COOKE
FAWCETT
ARCHITECTS

13 Derby Lodge
22.12.2016

CF_127_REP_161222_RevisedScheme

The items listed above are described in the original drawings submitted for listed building consent:

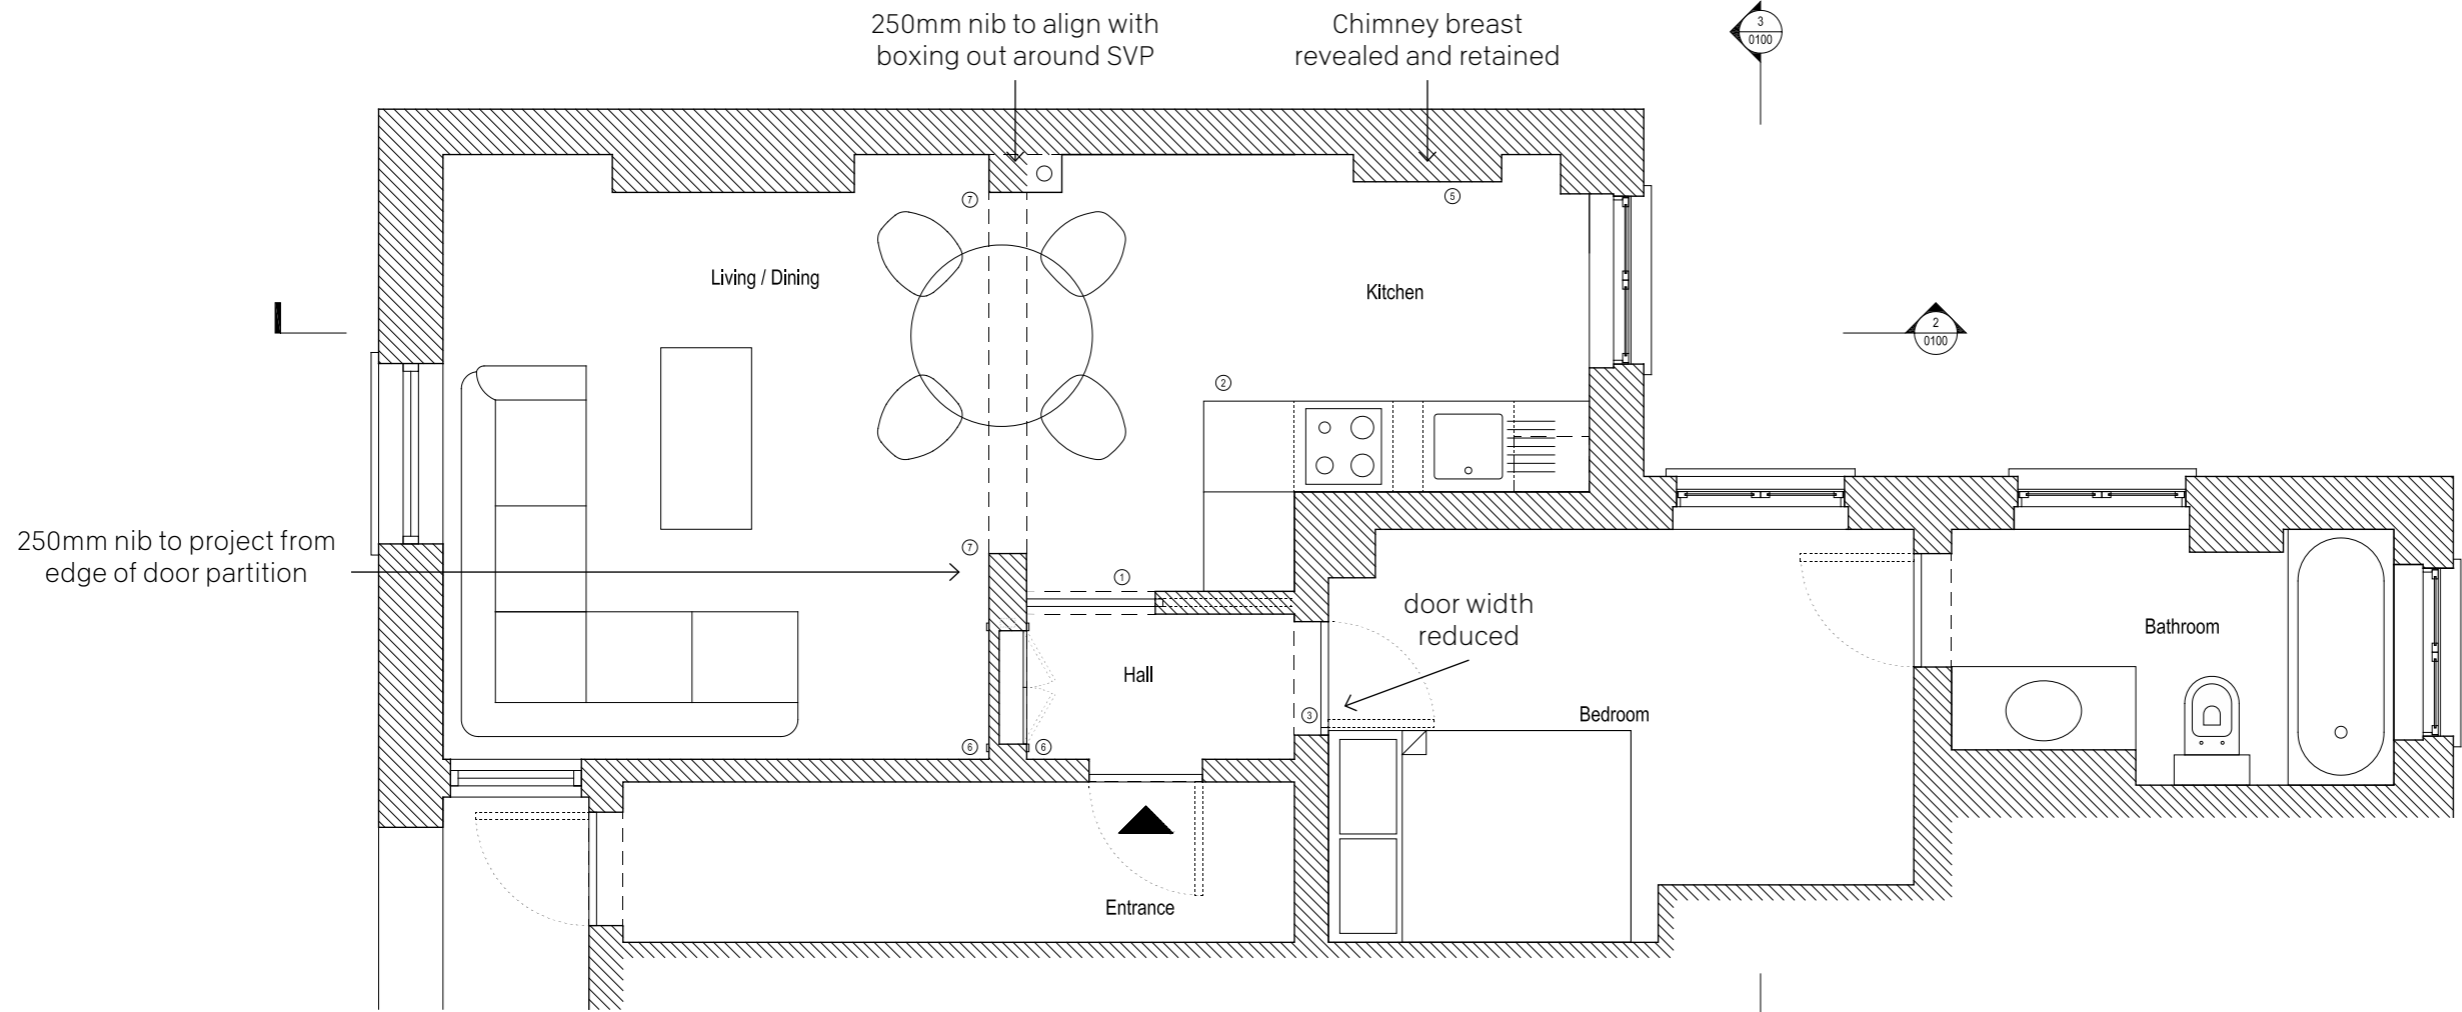
1. Removal of non-original kitchen linings to reveal chimney geometry
 - Further investigation to be carried out to determine geometry of concealed wall and location of assumed chimney breast.
2. Existing architraves should be retained around the doorway which is proposed to be closed up.
 - To retain memory of original door and layout
3. Reduction in the width of the proposed down stand beam
 - Beam should reflect width of existing partition wall.
 - 200mm deep down stand suggested
4. Proposed opening between kitchen and living room.
 - Additional existing fabric should be retained to maintain readable memory of original layout.
 - Proposed opening should be articulated as an opening within the existing wall.
 - Retention of two nibs, each of 250mm width, either side of the proposed opening has been suggested.

Regarding point 1, similar flats above and below the applicants property have been visited. The flat above retains the original chimney arrangement. This geometry has been surveyed to understand the size and location of the chimney breast running up this wall of Derby Lodge. This survey information has been incorporated in the revised existing and proposed drawings.

1 PLAN PROPOSED

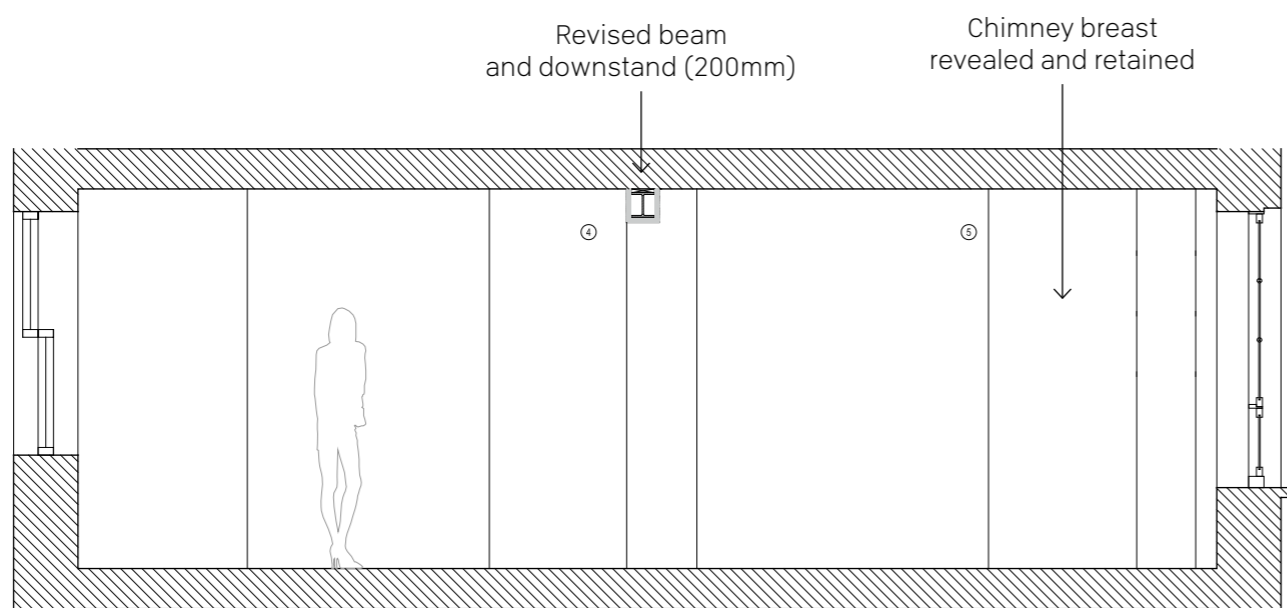
1. Alterations to a proposed down stand beam (forming the new opening mentioned above) to ensure the width of this element does not exceed the width of the existing partition.
2. Retention of a 250mm nib to both sides of the proposed opening.
3. Retention of an existing door architrave around a door opening which will be blocked up and converted to storage.
4. Identification of a single door leaf which is to be reduced in width to enable the door to open fully.
5. Identification of the location and dimension of an existing concealed chimney breast which is to be revealed to its original state as part of the works.
